5. Bayview Gardens Subdivision Addition 1 Jennings 2024 Replat KPB File 2024-109

# ITEM #5 - PRELIMINARY PLAT BAYVIEW GARDENS SUBDIVISION ADDN 1 JENNINGS 2024 REPLAT

KPB File No.	2024-109
Plat Committee Meeting:	October 28, 2024
Applicant / Owner:	Jennings Community Property Trust
Surveyor:	Katherine Kirsis / Seabright Survey & Design
General Location:	East Hill Rd Area, City of Homer

#### Staff Report 24-044

#### BAYVIEW GARDENS SUBDIVISION ADDN. 1 JENNINGS 2024 REPLAT

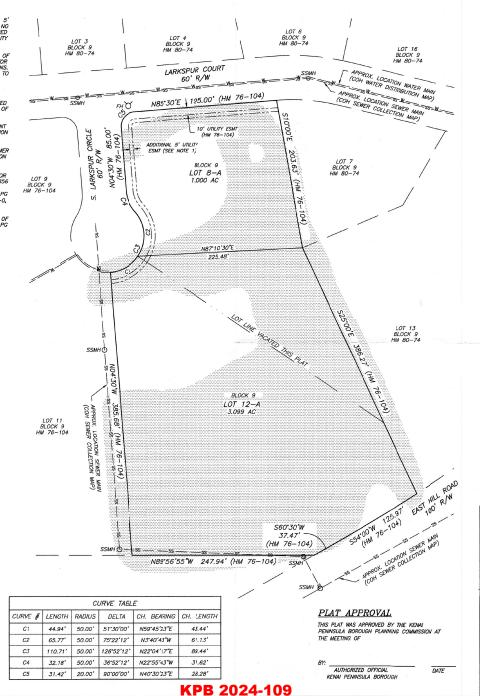
There are steep areas located on the property as indicated by the shading on the drawing. The slope is towards East Hill Rd and a ditch area on the east side of the plat. The shading an remain on the final submittal.

A soils report will not be required as city water and sanitary sewer are available to the lot from the City of Homer. The proper wastewater disposal note is on the plat and should remain for the final submittal.

The property is located in the City of Homer and was reviewed by the Homer Planning Commission at their regular meeting of September 4, 2024. The plat was presented and reviewed by the committee, meeting all city codes. Staff noted that the 15' utility easement needed to be modified on the drawing in reference to note #1. Item was voted on with non-objection and a unanimous consent. Motion was carried and approved.

The parent plat identifies a 10' underground utility on the front line that this plat labels as a10' utility. **Staff recommends** this easement be relabeled to match the parent plat. The plat labels the 5' of the 15' utility as "additional 5' utility easement". **Staff recommends** the 15' utility easement be labeled as such and noted as granted this plat and referenced to plat note 1, also mentioned by City of Homer.

The sewer easement noted in plat note #8 should be marked out on the south end off Lot 12-A as it affects that portion of the lot.

Add the date of October 28, 2024 to the Plat Approval

Modify the KPB File no. to 2024-109

Add Larkspur Ct to the vicinity map if possible

Add a label for the parcel to the south of the plat Lots to the northeast need the lots corrected

Add the easement for the sewer on the south end of lot 12

The parent plat dedicated a 10' underground utility at the front of the lot, correct label.

Correct label on new utility easement, city of Homer requested new 15' utility easement be labeled as such and change the label of addition 5' utility to 15' utility easement dedicated this plat.

**Staff Response:** The utility easement is depicted as a 10' utility easement per (HM 76-104), however it spells it out as a 15' utility easement in note #1. A 15' utility easement should be depicted on the plat too.

**Public Works Comments:** I noticed the utility easement is depicted as a 10' utility easement per (HM 76-104), however it spells it out as a 15' utility easement in note #1. We want 15' and it should be depicted that way on the plat.

1. The utility easement is depicted as a 10' utility easement per (HM 76-104), however it spells it out as a 15' utility easement in note #1. A 15' utility easement should be depicted on the plat too.

1. THE UTILITY EASEMENT IS DEPICTED AS A 10' UTILITY EASEMENT PER (HM 76-104), HOWEVER IT SPELLS IT OUT AS A 15' UTILITY EASEMENT IN NOTE #1. A 15' UTILITY EASEMENT SHOULD BE DEPICTED ON THE PLAT TOO.
